CITY OF KELOWNA
MEMORANDUM

Date: February 10, 2017
File No.: S17-0009

Subject: Subdivision Application – PLR Requirements

LOCATION:	757 Raymer Road
APPLICANT:	Integrity Services Inc
LEGAL:	Lot A Plan 26557

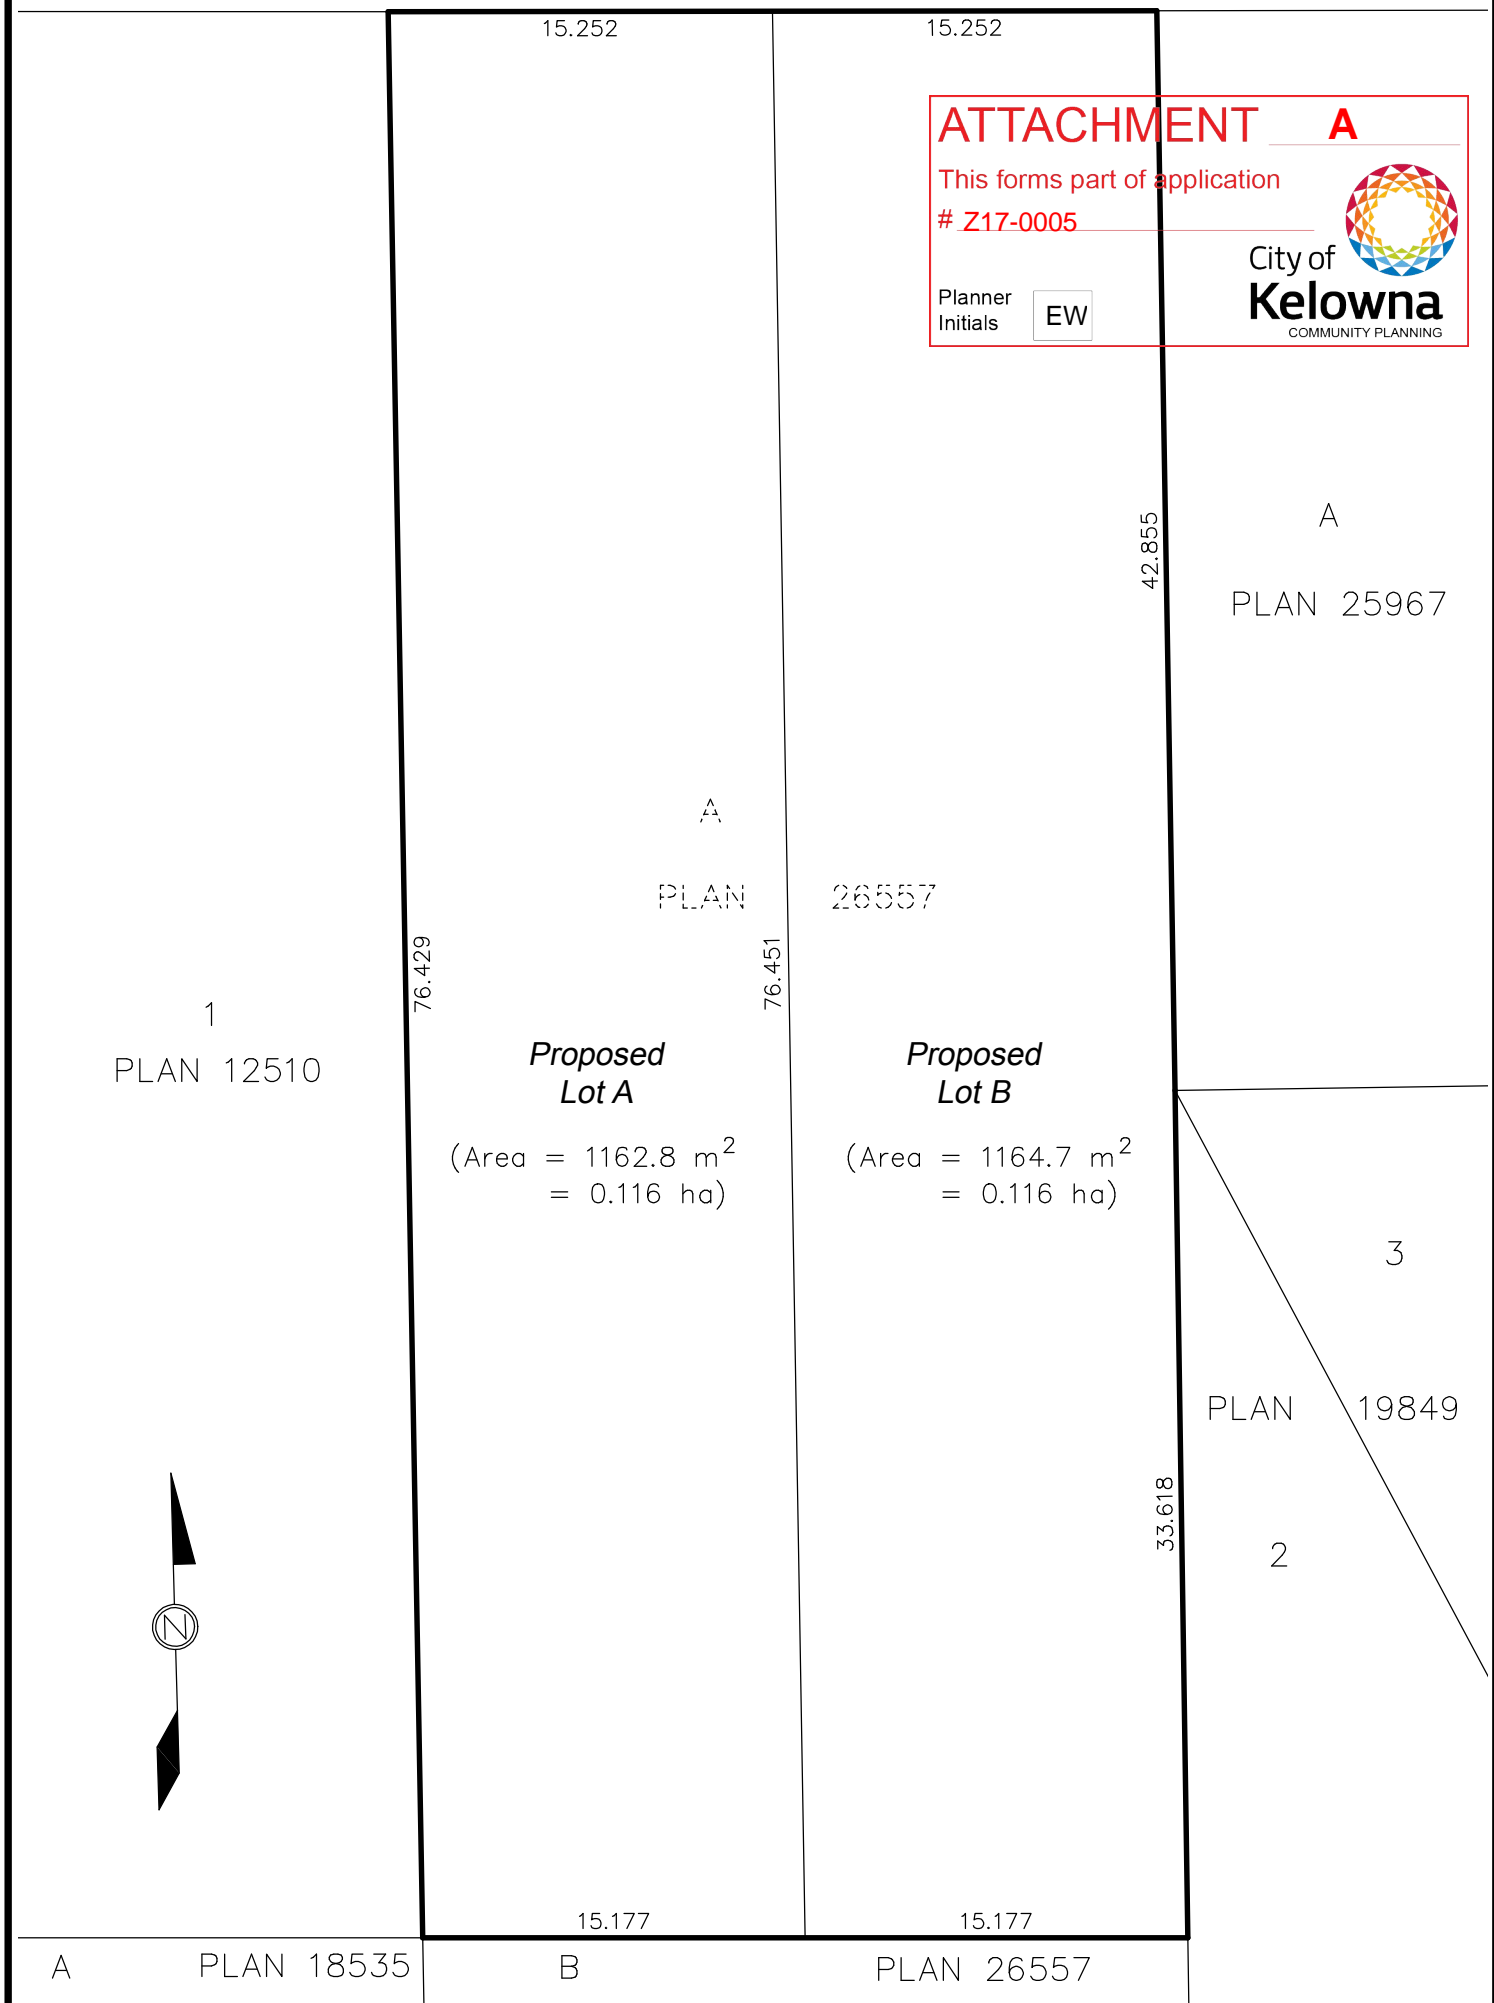
- a) The existing 100mm diameter service will be utilised to service proposed lot A.
- b) A new sanitary service can be provided at the applicant's cost prior to subdivision approval. The applicant will be required to sign a Third Party Work Order for the cost of the new service requirements. For estimate inquiry's please contact Sergio Sartori at ssartori@kelowna.ca or phone 250-469-8589.

- a) Raymer Road frontage must be upgraded to a full urban standard including curb, gutter, sidewalk, fillet pavement, street lights, storm drainage system, landscaped boulevard and adjustment and/or re-location of existing utility appurtenances if required to accommodate this construction.
